MELBOURNE METRO RAIL PROJECT ENVIRONMENT EFFECTS STATEMENT
INQUIRY AND ADVISORY COMMITTEE

MMRA TECHNICAL NOTE

TECHNICAL NOTE NUMBER: 012

SUBJECT: Franklin Street Legacy Condition

MAP BOOK REFERENCE: Map 7 (Horizontal Alignment Plans – Operation Phase)

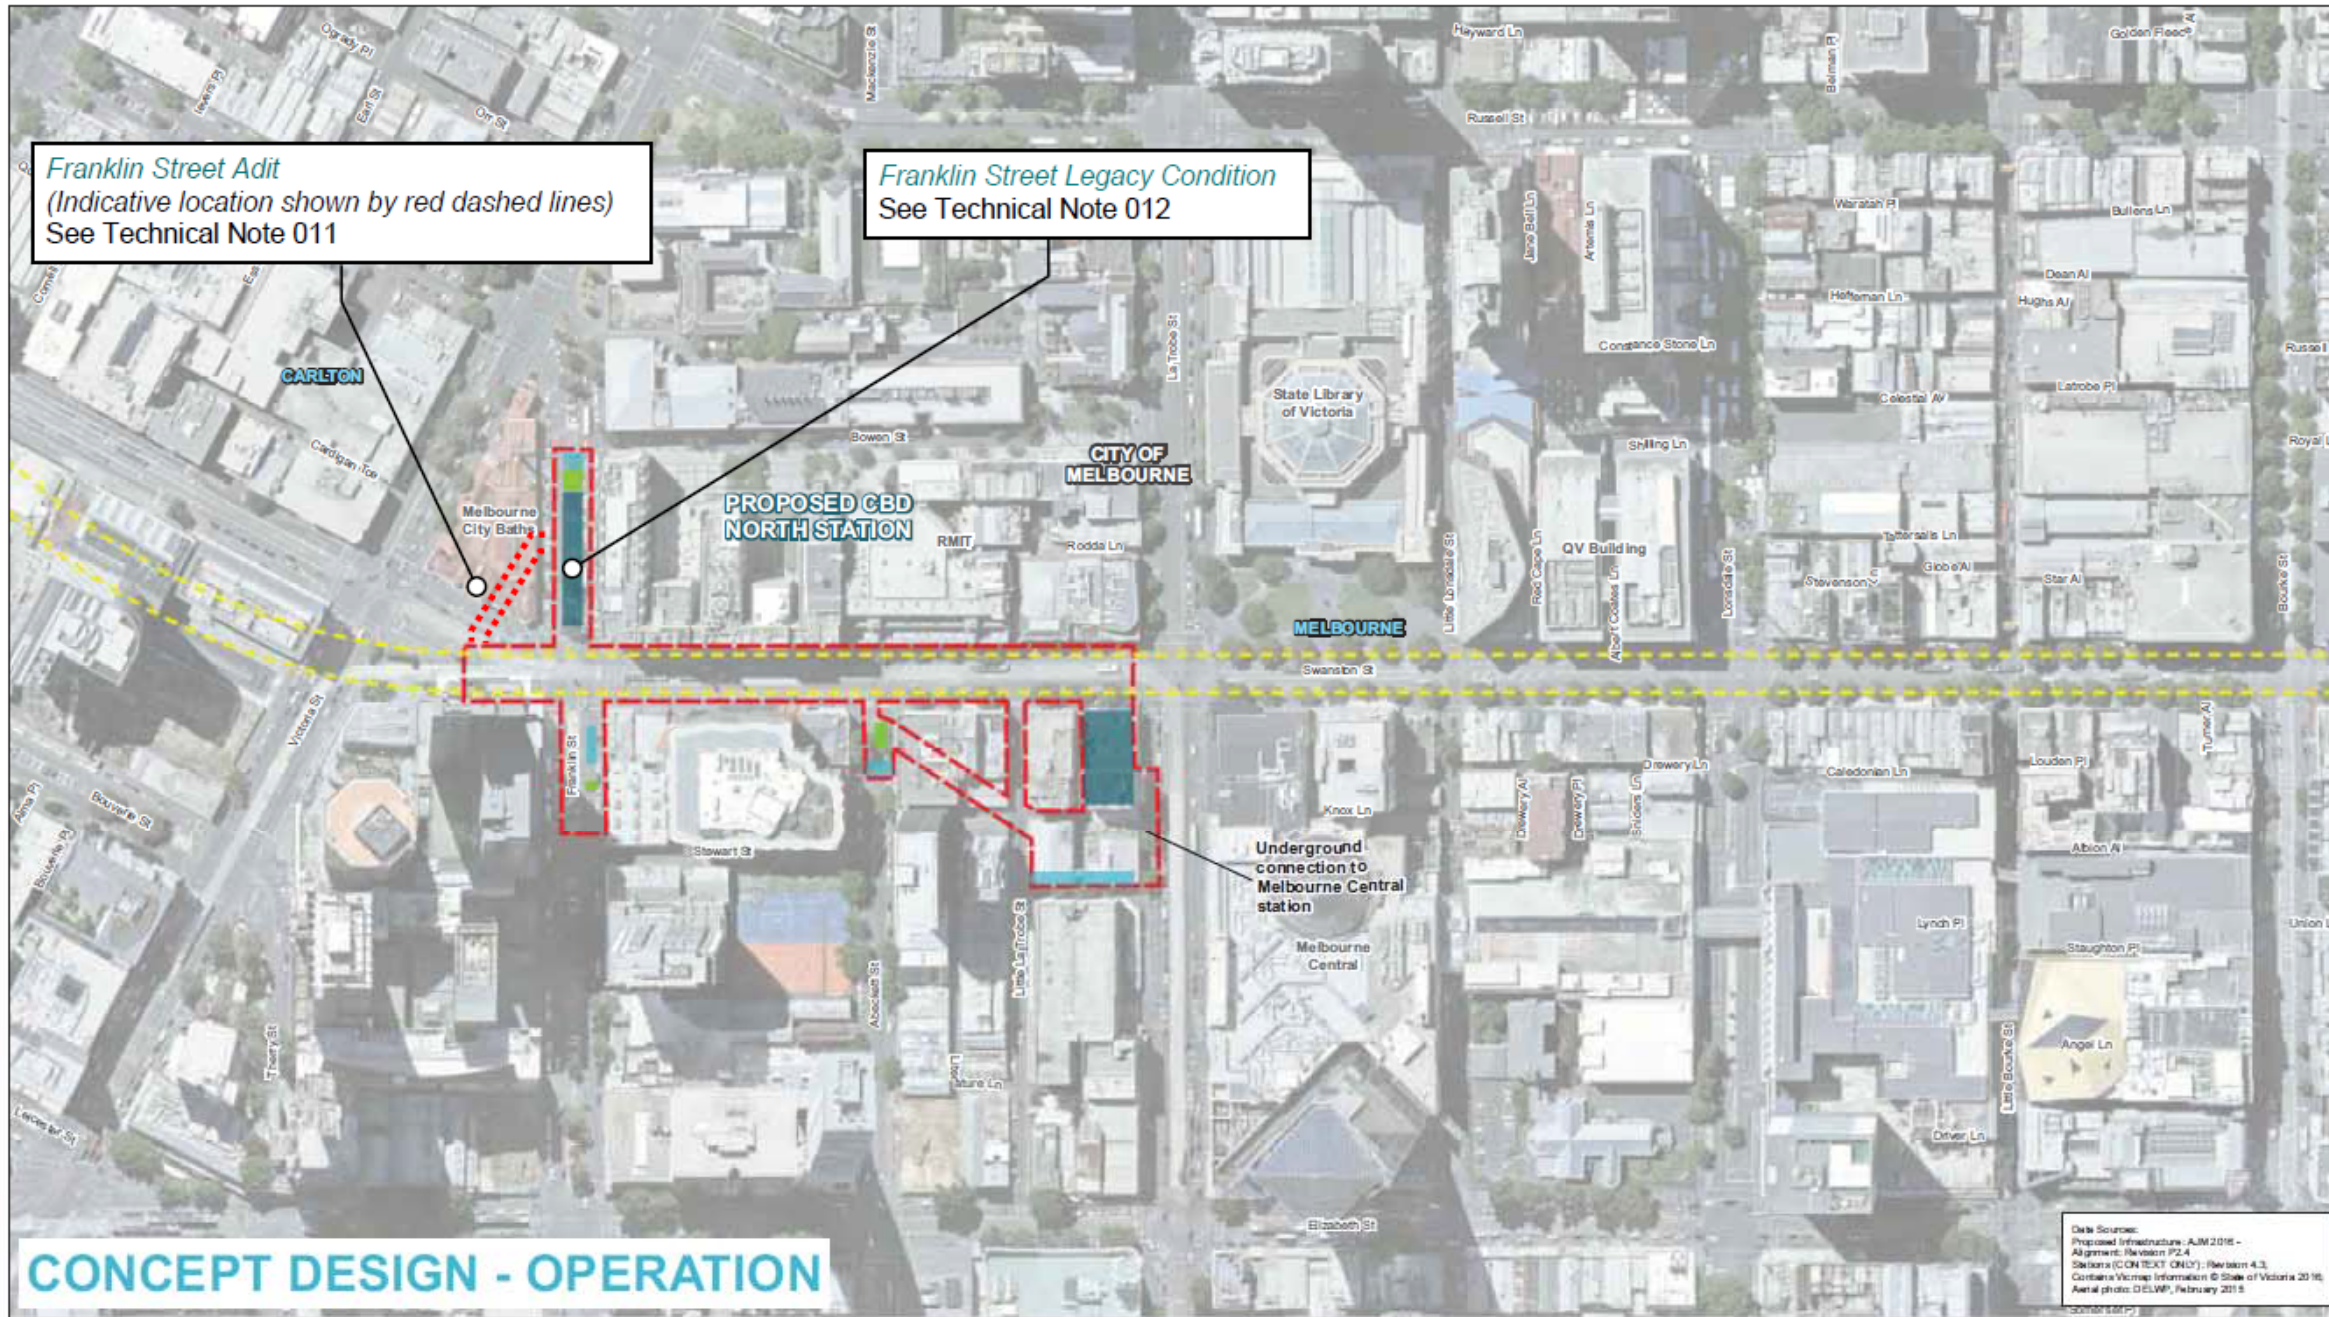
Franklin Street (east of Swanston Street) to be re-opened to traffic post-construction (in response to City of Melbourne request).

1. The Concept Design is based on a station entrance in Franklin Street that assumes Franklin Street will be permanently closed to traffic between Swanston Street and Bowen Street post-construction of the Project. Managed vehicular access would be provided to the RMIT loading area under Building 14. This assumption also formed the basis of the Traffic Impact Assessment exhibited as part of the EES.

2. The City of Melbourne, as the road manager of Franklin Street, has requested the reinstatement of two lanes of traffic (one in each direction) and bike lanes post-construction. The Concept Design can accommodate the outcome preferred by the City of Melbourne.

3. In response to the City of Melbourne's request, this modification involves the reconfiguration of the station entrance so that there is sufficient space within the road reserve for one traffic lane in each direction on Franklin Street between Swanston Street and Victoria Street, an east-bound bicycle lane, and access to the RMIT loading area under Building 14 (refer to Attachment A).

4. Implementing this change will allow traffic to continue to use Franklin Street and address the City of Melbourne's requirements for the reinstatement of two lanes of traffic in Franklin Street in the Project's legacy arrangement. This is also consistent with the City of Melbourne's
